James Scarola
Vice President
Harris Nuclear Plant
Progress Energy Carolinas, Inc.

Serial: HNP-05-103
10 CFR 50.90

SHEARON HARRIS NUCLEAR POWER PLANT, UNIT NO. 1
DOCKET NO. 50-400/LICENSE NO. NPF-63
REQUEST FOR LICENSE AMENDMENT
TO CREDIT SOLUBLE BORON FOR FUEL STORAGE POOLS

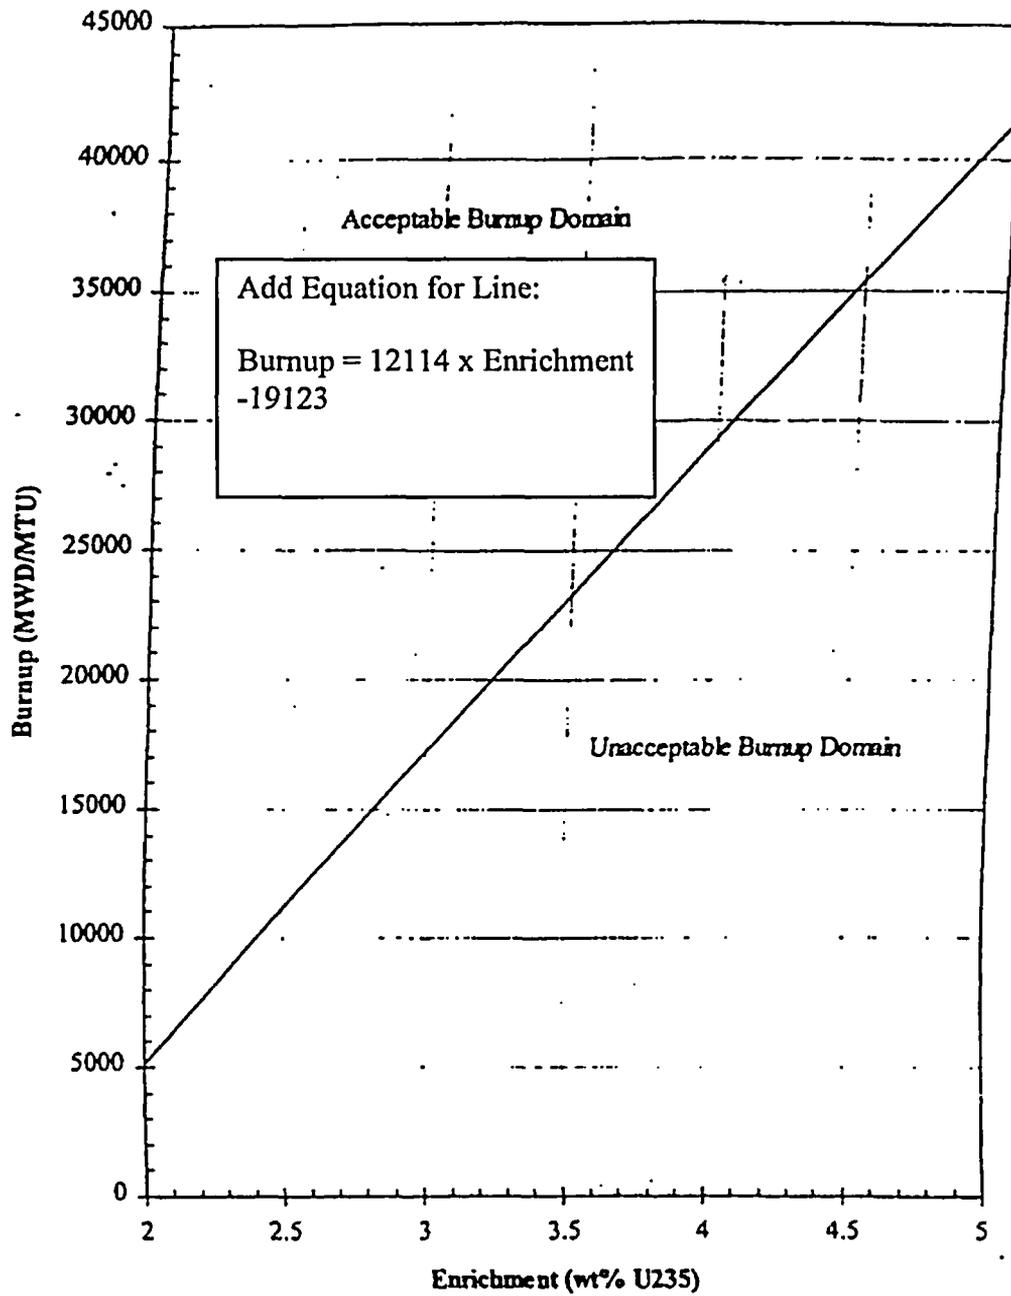
5.6.1 The ~~spent~~ fuel storage racks are designed and shall be maintained with k_{eff} less than or equal to 0.95 when flooded with unborated water. ~~which includes an allowance for uncertainties as described in Section 4.3.2.6 of the FSAR.~~

The reactivity margin is assured for pools "C" and "D" by maintaining a nominal 9.017 inch center-to-center distance between fuel assemblies placed in the non-flux trap style PWR storage racks and 6.25 inch center to center distance in the BWR storage racks. The following restrictions are also imposed through administrative controls:

1. PWR storage racks in pools "A" and "B"
 - a. k_{eff} less than or equal to 0.95 if fully flooded with water borated to 2000 ppm.
 - b. k_{eff} less than 1.0 if flooded with unborated water.

2. Dry New Fuel PWR Storage Racks
 - a. Fuel assemblies having a maximum U-235 enrichment of 5.0 weight percent.
 - b. $k_{\text{eff}} \leq 0.95$ if fully flooded with unborated water without credit for Boraflex in the rack module.

3. BWR Storage Racks in Pools "A" and "B"

Figure 5.6-2
Pools "A" and "B" BURNUP VERSUS ENRICHMENT FOR PWR FUEL

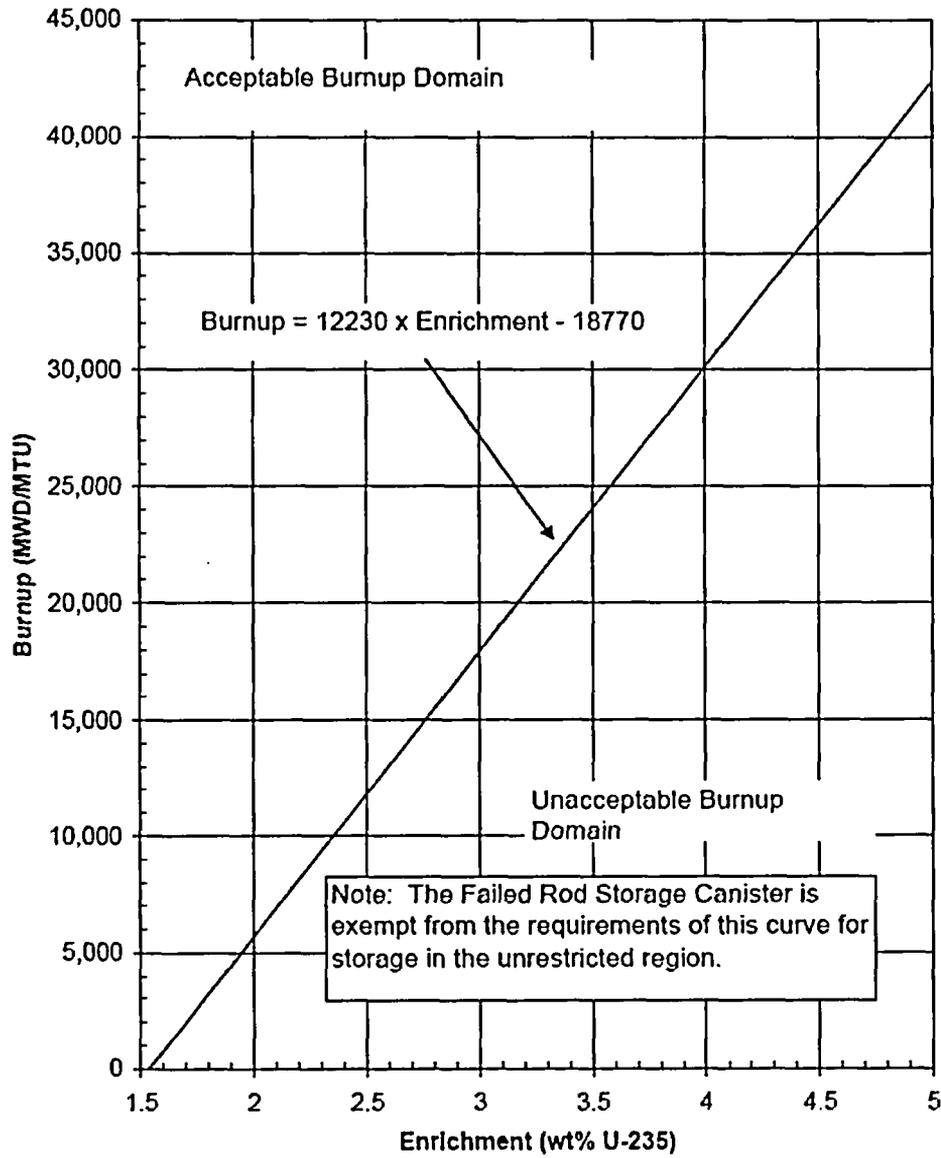
- A revision to Figure 5.6-1 is made to add the equation for the burnup curve and revise the title so that the existing figure is consistent with the proposed content of new Figure 5.6-2. The curve in Figure 5.6-1 is not changed.
 - A new Figure 5.6-2 is added to define the PWR fuel that meets the unrestricted storage in the Boraflex racks in Pools "A" and "B."
 - The specifications for the dry storage of new fuel are being added to TS Section 5.6.1.
3. A new TS Bases section has been added for the new TS 3/4.7.14 to provide information related to the criticality analyses and the various analysis assumptions, such as credit being taken for soluble boron for the Boraflex racks. An information copy of the proposed Bases change is also included with this submittal.

1. The attached TS Figure 5.6-2 includes a specific exclusion for the HNP Failed Rod Storage Canister (FRSC). The FRSC can hold up to 54 PWR failed rods with a maximum initial enrichment of 5 weight-percent and no burnup. The calculated k_{eff} of the basket is 0.682. This is much lower than the k_{eff} of a BUC-region qualified fuel assembly, and therefore placement of the FRSC in the 4-of-4 region with low burnup rods is acceptable.

- c. A nominal 10.5 inch center-to-center distance between fuel assemblies.
 - d. Assemblies must be within the "acceptable range" of the burnup restrictions shown in Figure 5.6-2 prior to storage in unrestricted storage.
